COMMENTS 2.1
on the
Environmental Scoping Report
for
The First Polish Nuclear Power Plant
(PGE_SCN_DES_0001_EN_2.0)
made by PGE EJ 1 sp. z o.o.

Ir. Jan Haverkamp
expert consultant on nuclear energy and energy policy
Greenpeace in Central and Eastern Europe
25 January 2016

Lubiatowo-2 | Effective dose infant 07 d
Release B | 125.2 PBq (13.700%) of Cs-137, etc.
Simulation start 19950906 19 stop 19950921 19

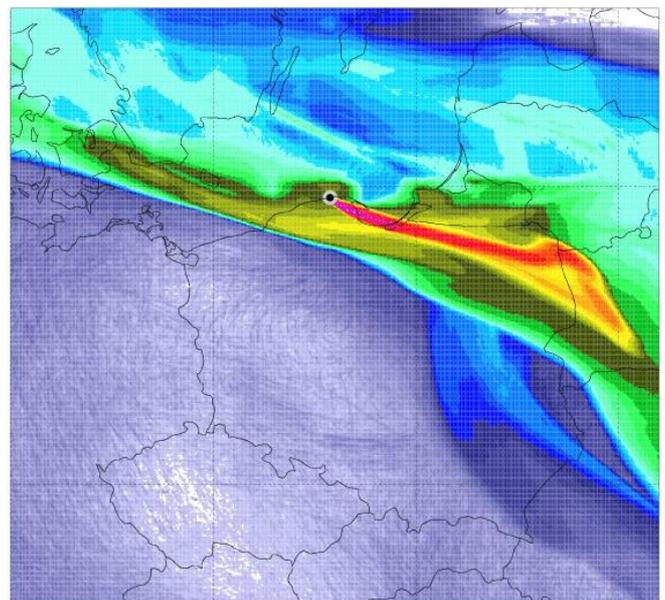
Greenpeace has asked the Institute for Safety and Risk Research at the BOKU University in Vienna to calculate potential source terms of the most important radioactive substances during accident situations in extreme circumstances that should be taken into account in the environmental impact assessment of a nuclear power station at the Choczewo site.¹⁵ It asked the department of Meteorology and Geophysics of the University of Vienna to calculate spreading and deposition with the widely used FlexRISK model.¹⁶ We want these calculations to be taken into account in the EIA report.

CONCLUSION: PGE should be required to include BDAs in its analysis that lead to a substantial release of radioactive substances in an early phase of the accident in the order of magnitude of several percent to 50% of the inventory of radioactive iodine, caesium and strontium and analyse the impacts for real weather simulations. It should furthermore indicate in detail how the fifth layer of defence in depth is to function under these circumstances, and include estimated impacts on health, economy and environment for such scenarios.
